# SONY® Service Bulletin

NO: HIFI2-99-015

SUBJECT: PART NUMBER CORRECTION

MODEL (S): MDS-S38, MDS-S39, MDS-JE500, MDS-JE510

## 7-4. MECHANISM DECK SECTION 2 (MDM-3B)

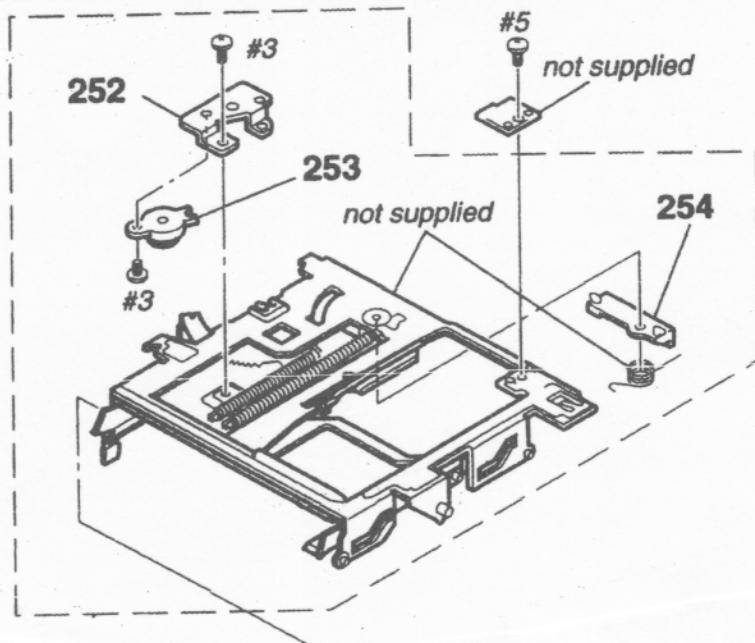
**Symptom:** The part number and description listed in the Service manual for the Lever (limiter) is incorrect.

**Solution:** Use the following number when ordering:

REP	DESCRIPTION		PART NUMBER	
	INCORRECT	CORRECT	INCORRECT	CORRECT
254	SLIDER(CAM)	LEVER(LIMITER)	4-983-437-01	4-979-901-21
